Re **Submission of objection**
 Development Application No. 10.2017.516

DA No 10.2017.516.1

Proposal Subdivision to Create Four (4) Lots

Description Street Address: 8 Coomburra Crescent OCEAN SHORES

Diagram of Proposed Subdivision:-

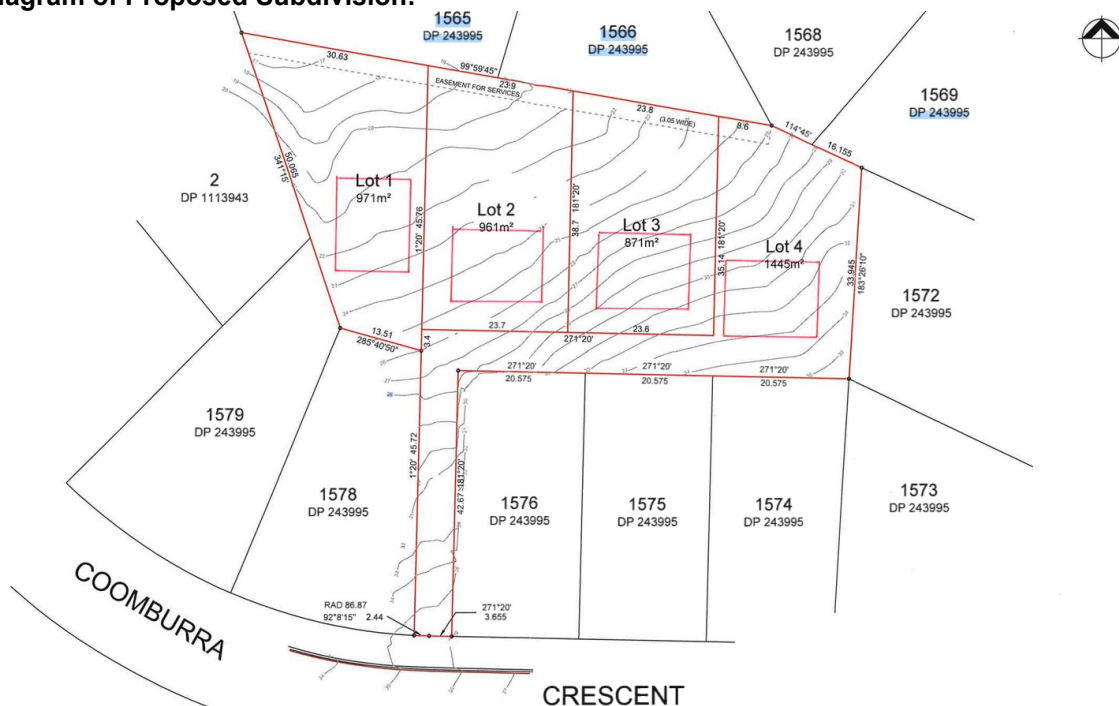
My clients have strong objections in relation to the loss of privacy resulting from the potential for overlooking in relation to dwellings to the north and west, driveway noise in relation to dwellings to the east and west of the access driveway, driveway design, stormwater run off in relation to allotments to the north, loss of residential amenity as a result of the removal of all of the significant trees on site and the construction of large retaining walls, loss of residential amenity

likely to result from the long term development potential of the site, traffic safety at the entry point onto Coomburra Cres., potential for property damage resulting from the earth works required for access, inability of the access driveway to cope with the numbers and types of vehicles likely to be generated by the development, the geological stability of the site for the purpose proposed given the slumping of ground already evident on site, and the significant inter-allotment drainage issues not identified on the plan of subdivision.

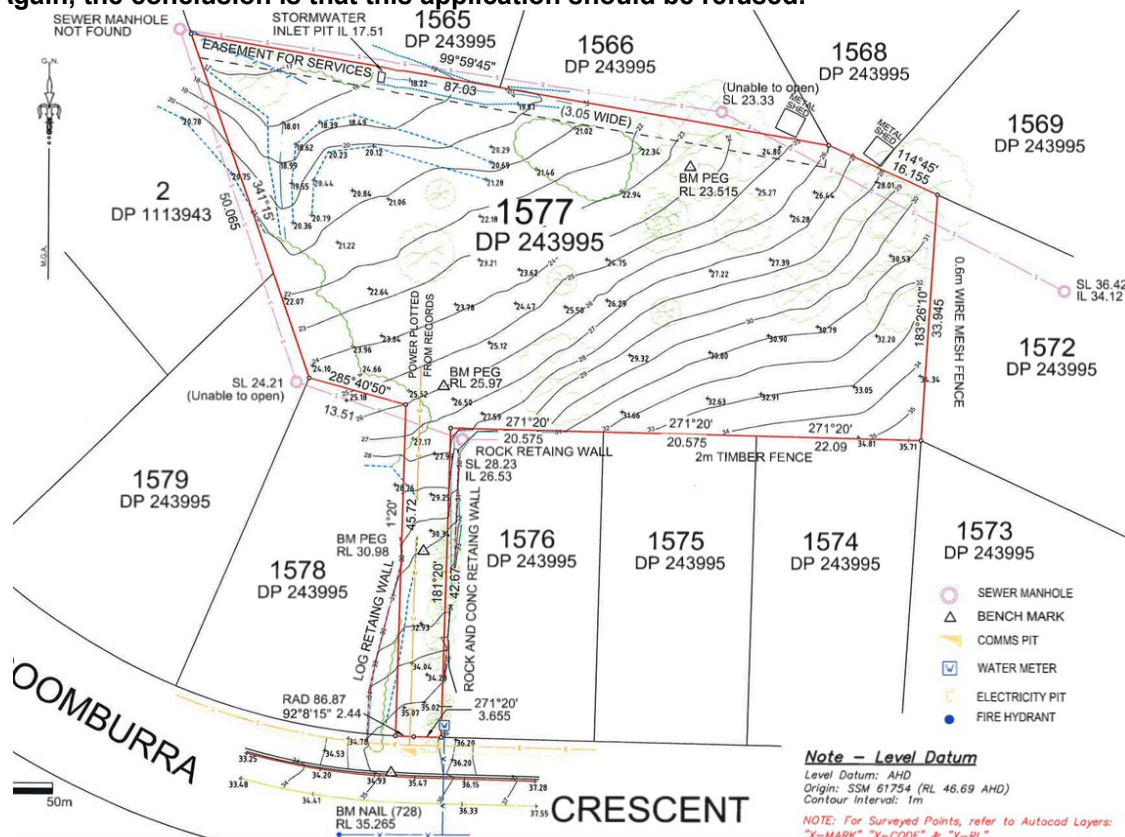
This will exceed the capacity of the proposed driveway, which although proposed at 6m, sits within a 6m wide strip, which provides no scope for landscaping, visibility splays adjacent to Coomburra Cres., safety rails, or garbage bin storage, or letter box placement.

The provision of such features within the proposed driveway will necessitate its narrowing, thus making it incapable of dealing with the likely traffic volumes it is meant to handle. Also as, as previously indicated, the geometry of the 90 degree bend at the northern end of the initial steep slope, does not permit the movement of large vehicles which may need to access the site, e.g. removal vans, fire appliances, builders trucks, and delivery vehicles. Again the eastern component of the driveway leading to proposed Lot 4, does not show details of the earth works required, retaining walls, to the north and south, or given the grade drop down to Lots 1, 2 and 3, and how vehicular access will even be possible onto these lots which can meet "the Northern Rivers Development and Design Manual".
